**Flood Control Project Maintenance
Levee Inspections**

Fall 2015 Levee Maintenance Deficiency Summary Report

Reclamation District No. 0765 Glide

Levee Inspection Report By Mile - Fall 2015

Photo 3 of 3 : UCIP_FA_2015_3839.jpg

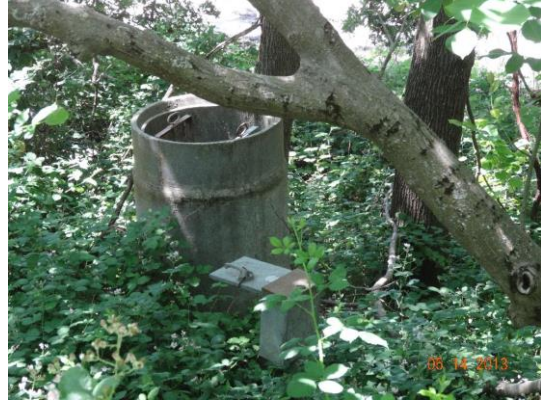
LM Start	1.11	Rating **	M	Issue No.	65 (cont)
LM End	1.11	Issue Type +	En	Location *	LS
Category	Supplemental			GPS Latitude/Longitude	
				Start	End
Item	DWR UCIP Field Study			38.487917 °	38.487917 °
				-121.554405 °	-121.554405 °
DWR ID					
Action/Comments					
Inspector Comments: FS_ID:44407					
DS_ID:21140					
EP_NO: N/A					
FS_HLM: 1.127					
Repair Type: Non-Urgent					
Crossing Status: Indicator Found

Overview of landward side--concrete standpipe and control panel located at toe.
